# **AUBURN PLANNING BOARD MEETING**

Re: Special Exception and Site Plan Review for a:  
Family Dollar Store proposed at 850 Minot Ave., (PID # 207-078)

RE: Proposed Family Dollar Store  
850 Minot Avenue  
Auburn, Maine

**UTILITY PLAN**

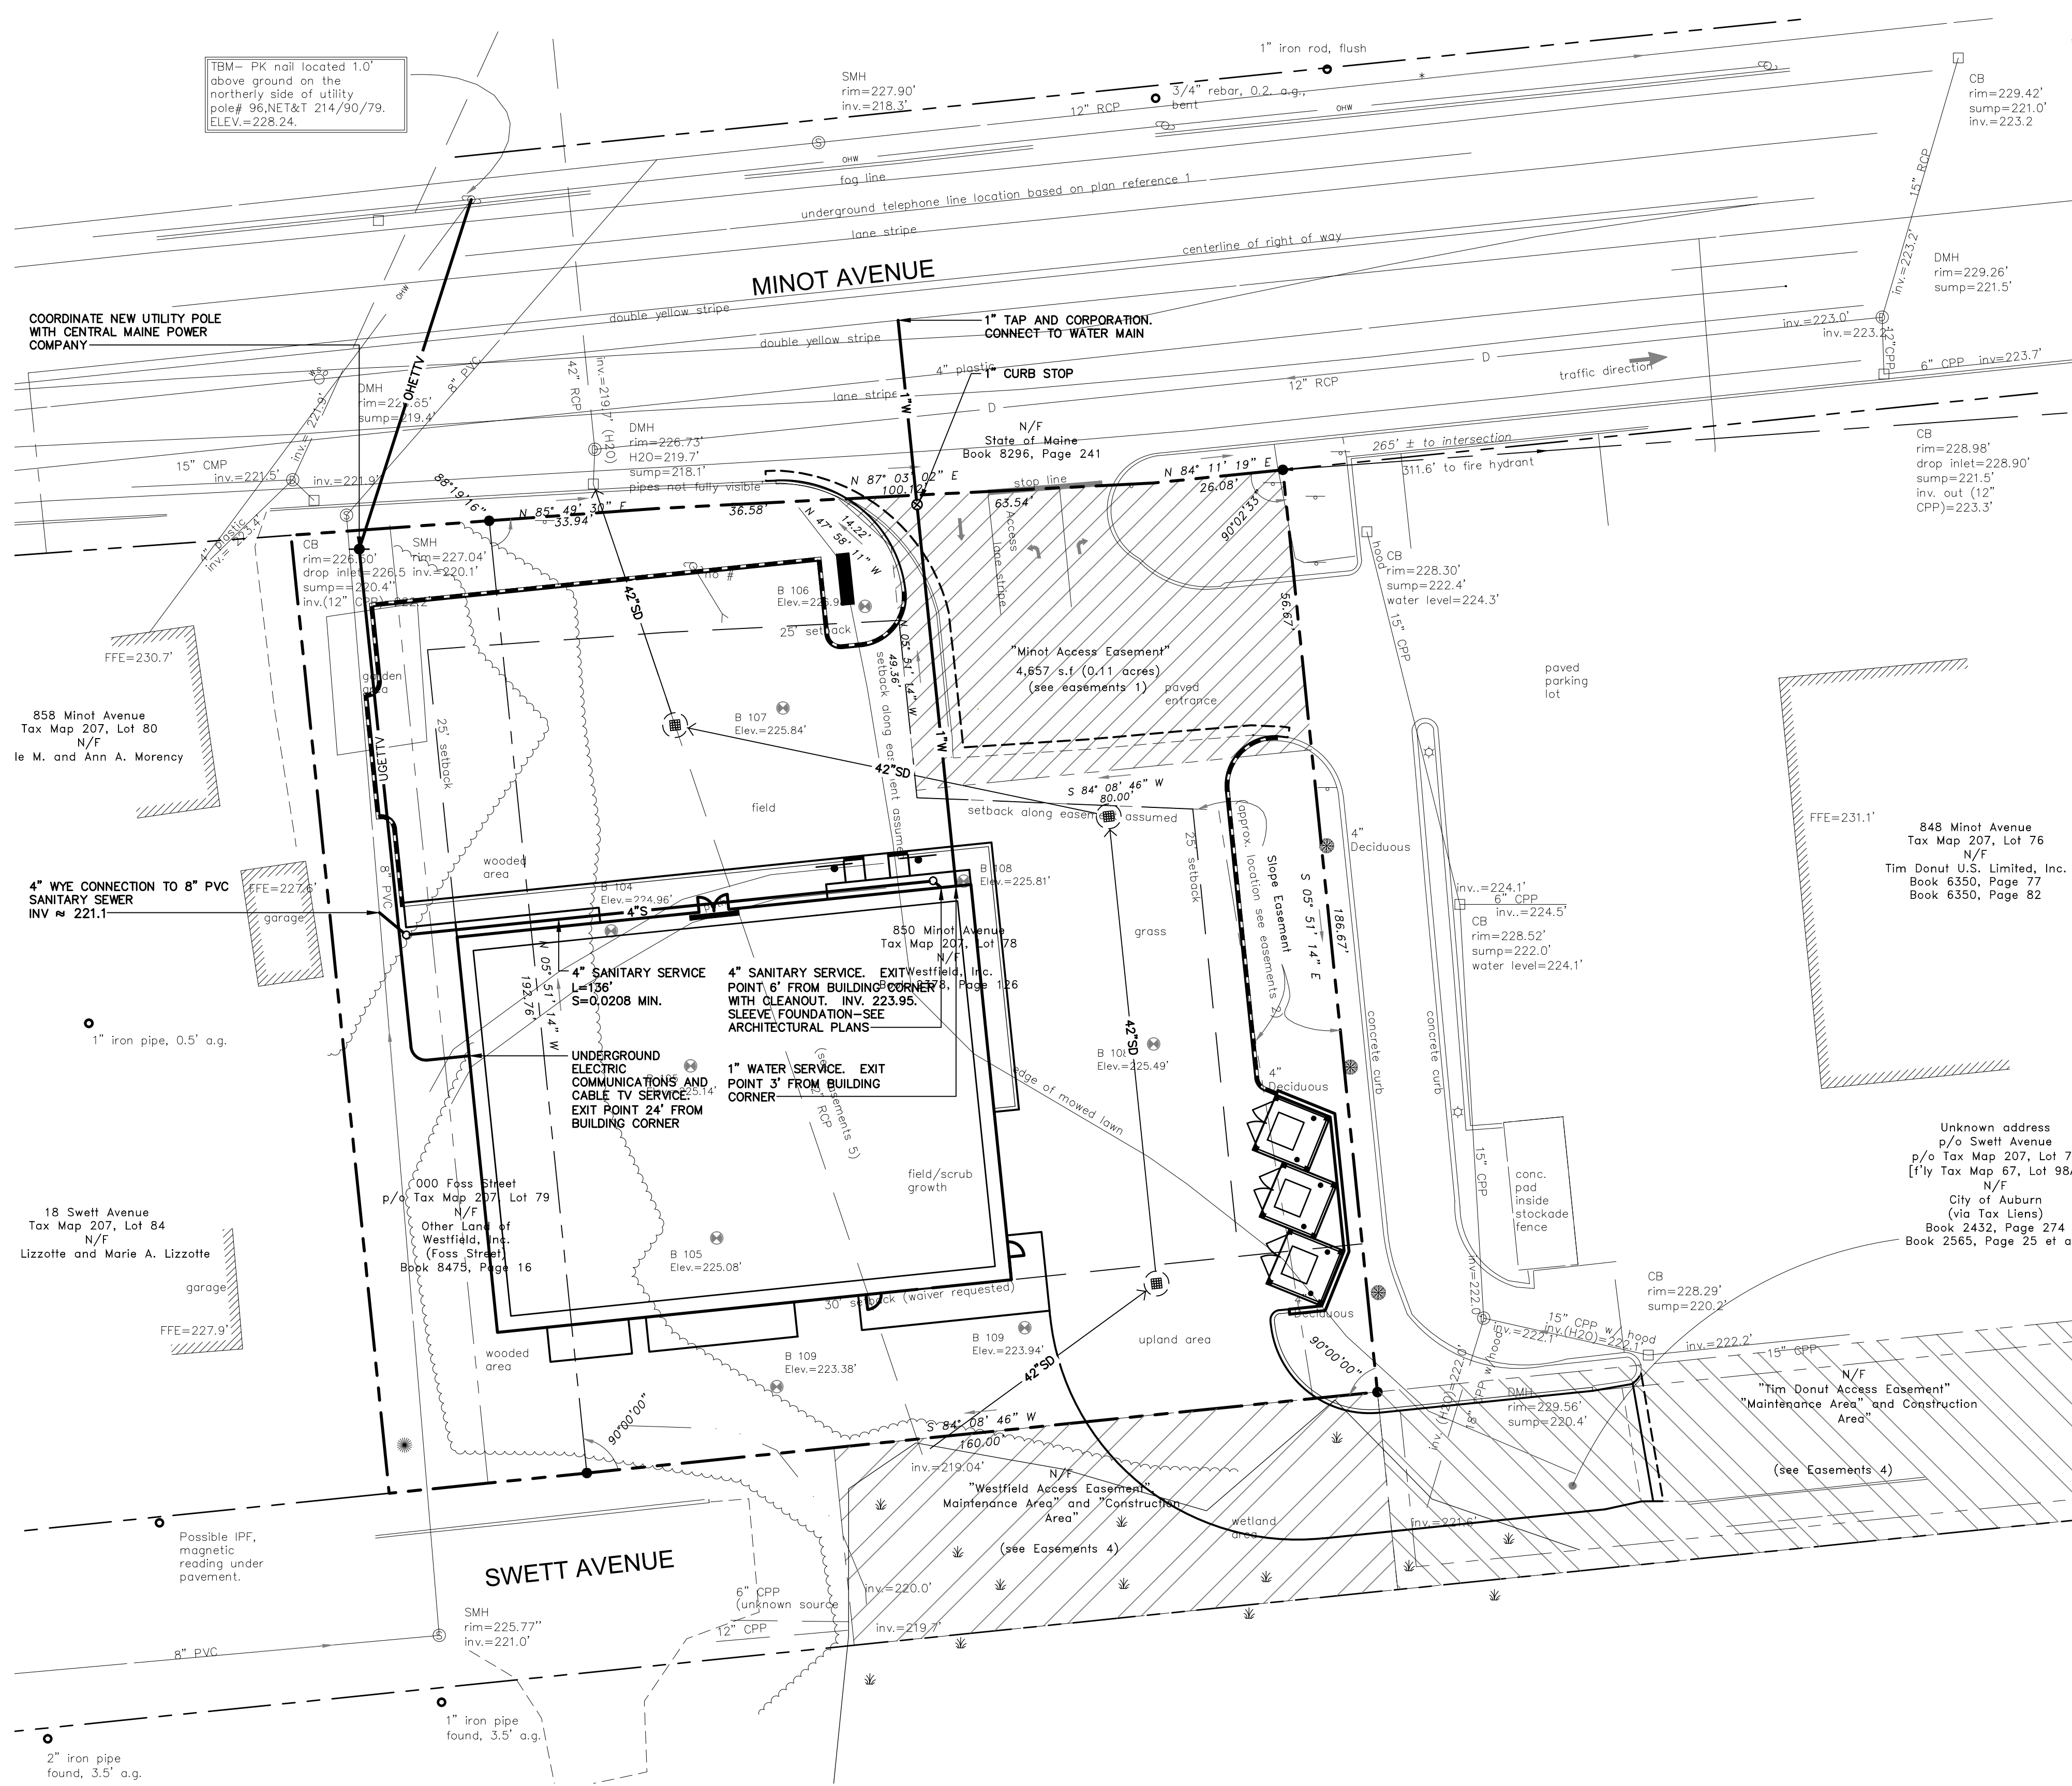
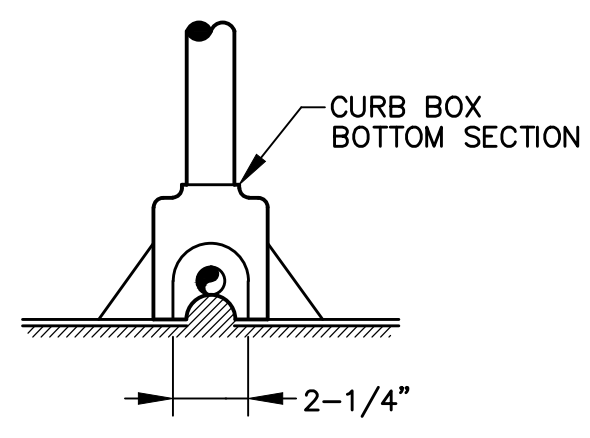
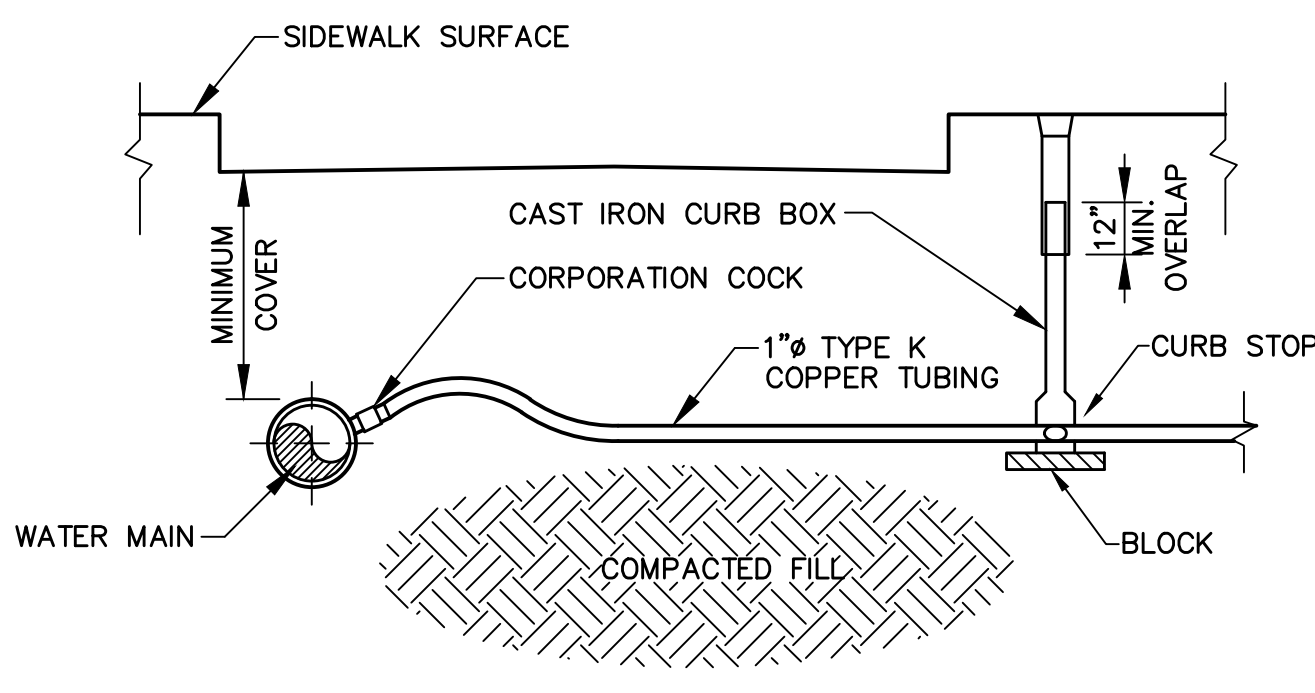
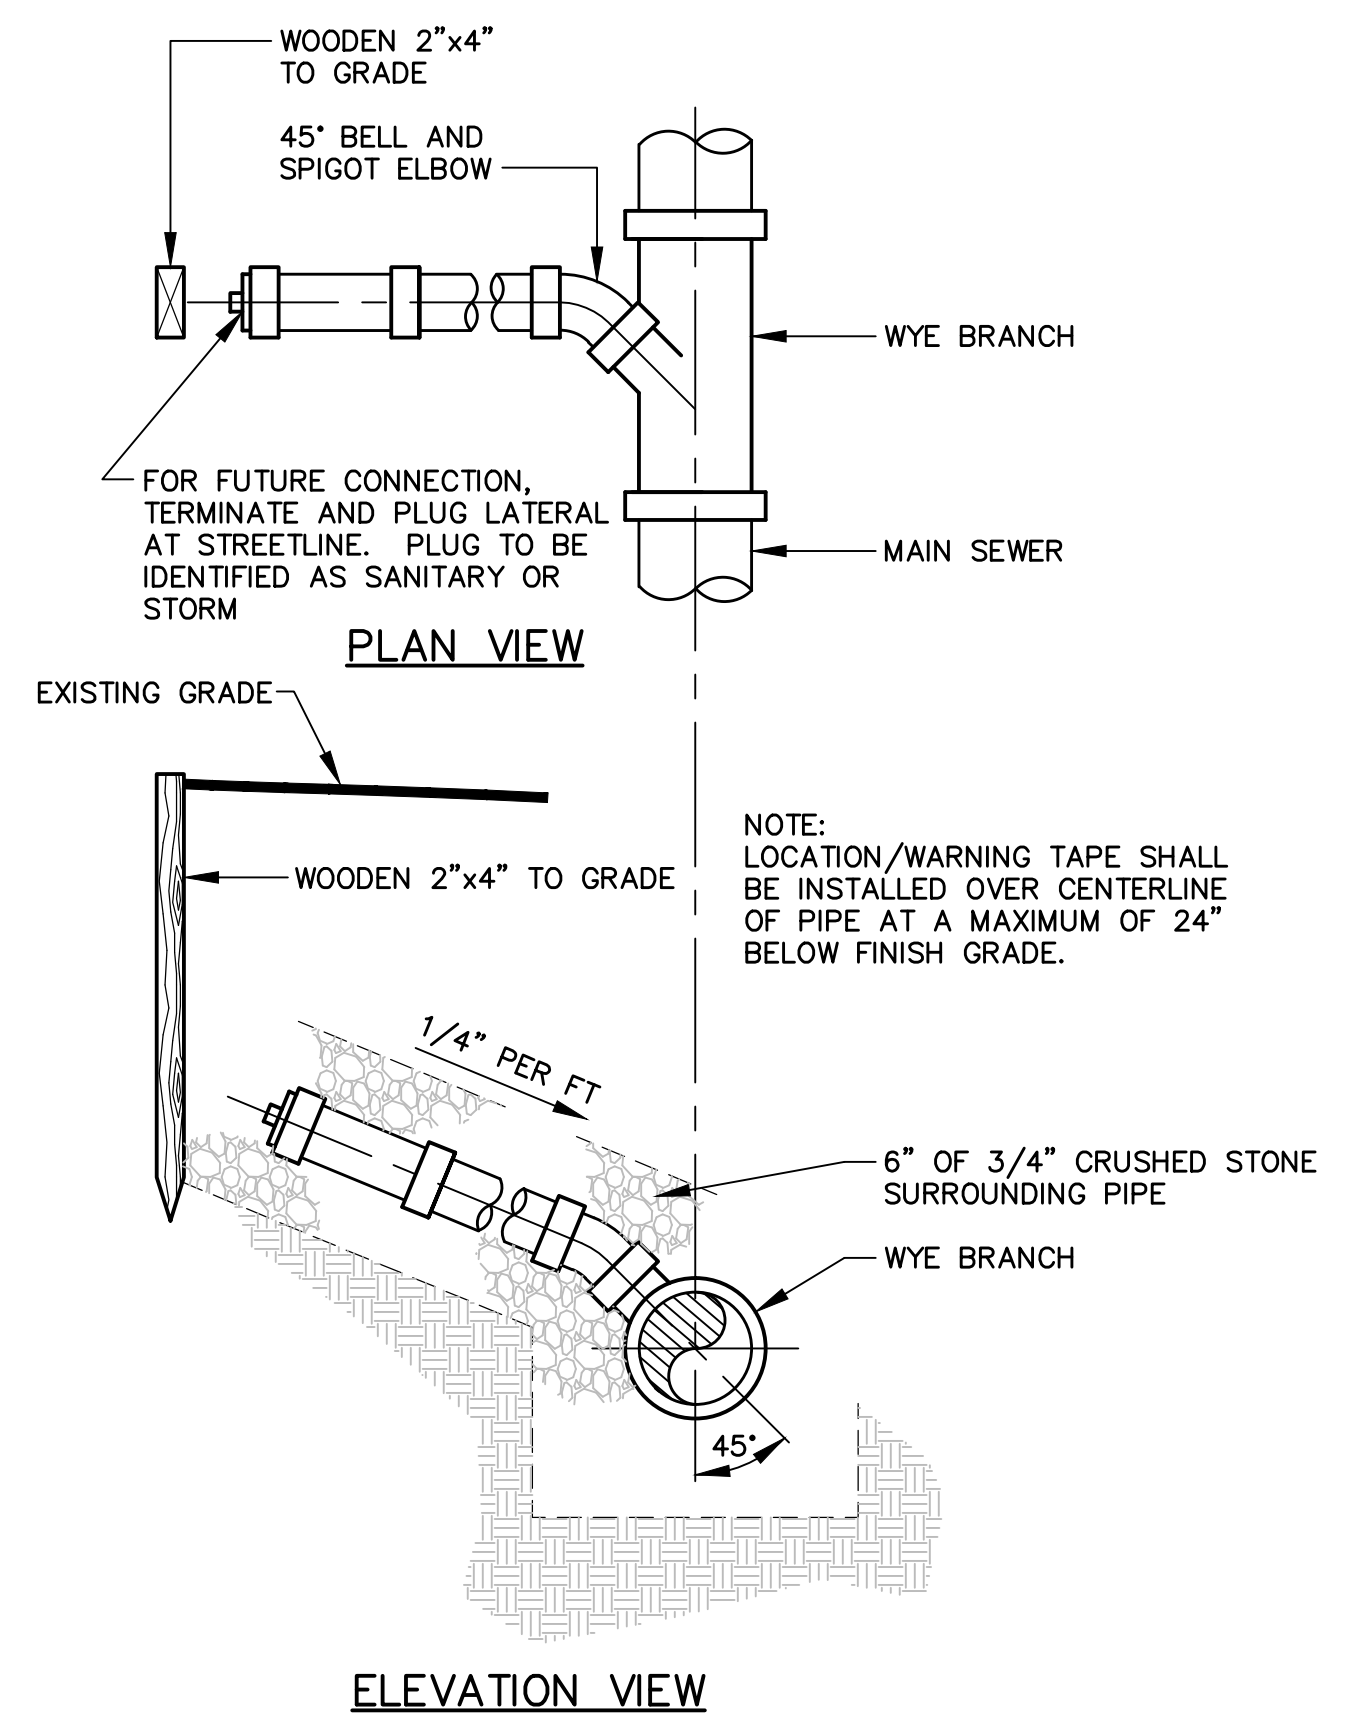
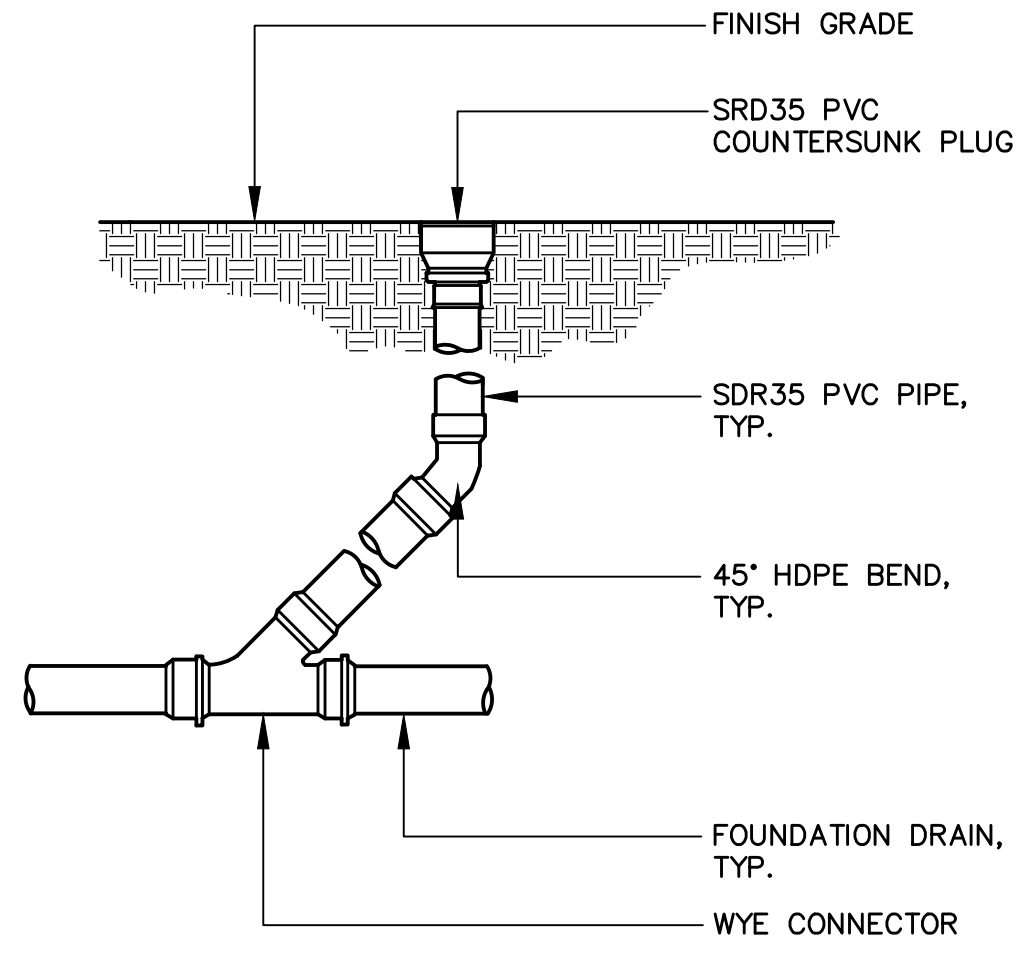
The Water and Sewer District raised concern over the location of a concrete utility pad near an existing sanitary sewer easement. The applicant has moved that utility pad to the rear portion of the building where no utility easement conflict exists. The site plan also includes a relocated utility pole close to the existing sanitary sewer easement along the western boundary of the property.

As you pointed out to me, we have a concern with the most recent design plans dated 2/7/2014. Drawing C-102 (Utility Plan) shows the proposed installation of a new utility pole and underground electric service to the building. The pole is nearly on top of the existing sewer line, as is the underground electric conduit. We have a 20' easement for the sewer line, and would like to see the pole and service relocated out of the easement area.

I see the latest plan shows that the concrete utility pad has been moved from the location previously shown on sheet C-100 of the December plan.
